IN THE DRAWINGS

PATENT
Docket: 90065.022702
Reply to Office Action of Aug. 5, 2003

FIG. 18a

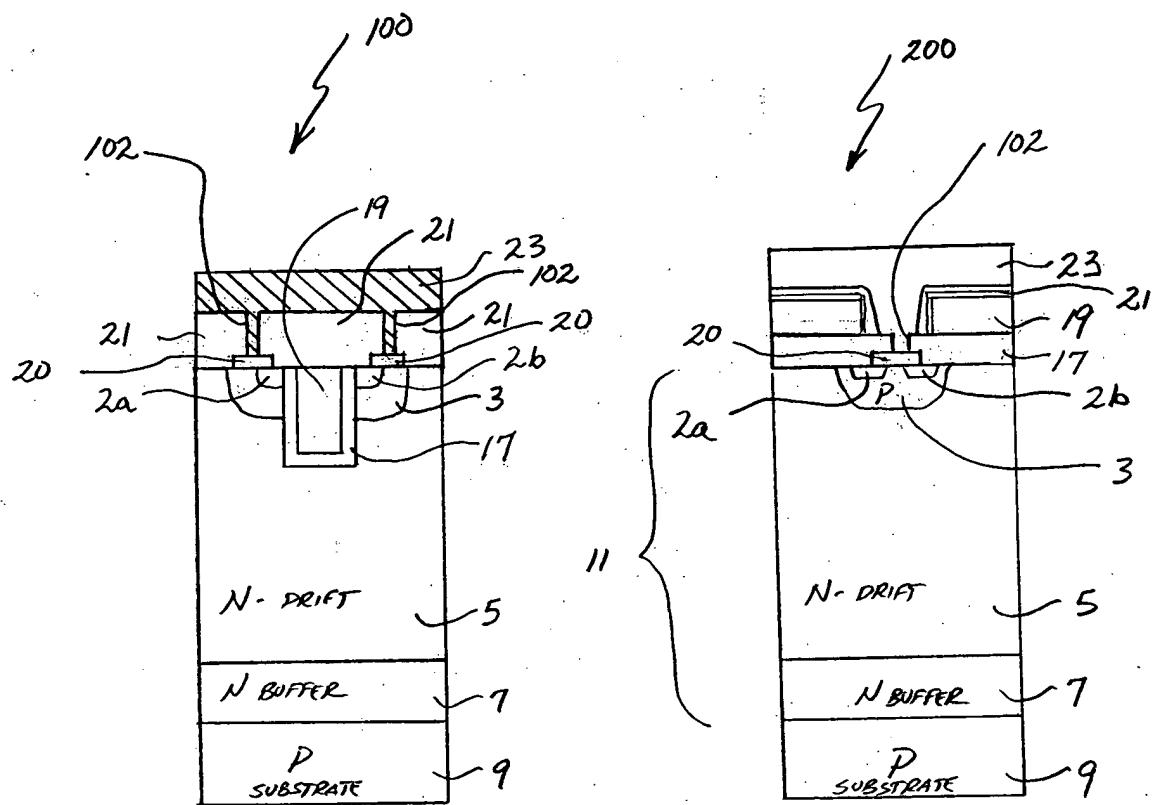
The drawings were objected to under 37 CFR 1.83(a) for failing to show:
1) source segments having different lengths; 2) source stripes having a doping concentration different from the doping concentration in the source contact regions; and 3) a single insulating layer completely covering the source stripes.

Responsive to the objection to the drawings for failing to show a single insulating layer completely covering the source stripes, as claimed in claim 35, Applicants propose the addition of Figures 18a and 18b. Figure 18a shows the 20 structure recited in claim 35, whereas Figure 18b shows the structure recited in

claim 28, and therefore Applicants submit that Figures 18a and 18b do not constitute new matter.
